Product Change Notice (PCN)

PCN Number: PCN-0451156R-01

Product(s) Affected: PJ-039A, PJ-039B, PJ-039AH, PJ-039BH

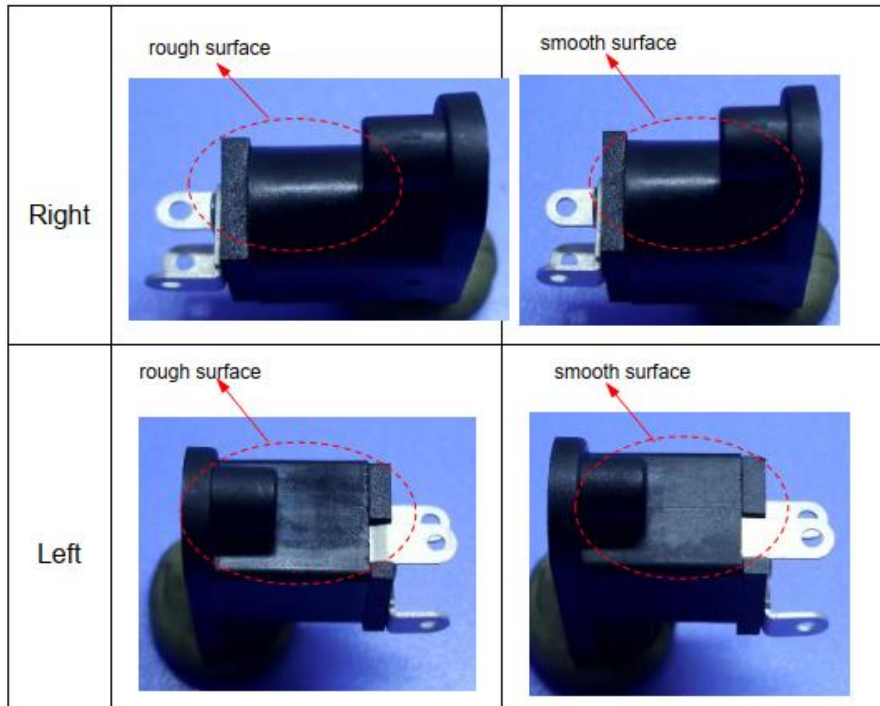
Description of Change: Thickness of pin 2 changed from 0.2mm to 0.25mm. Aesthetic changes as shown in below comparisons:

Current version	New version
Outlook		
Front	<p>without chamfer</p> 	<p>with chamfer</p>

Back	<p>cave marking location</p>  <p>smaller</p> <p>cave marking location</p>	<p>cave marking location</p>  <p>thicker</p> <p>cave marking location</p>
Top	<p>with injection mark</p>  <p>thickness of pin#2 is 0.2mm</p>	<p>without injection mark</p>  <p>thickness of pin#2 is 0.25mm</p>
Bottom	<p>without injection mark</p> 	<p>with injection mark</p>
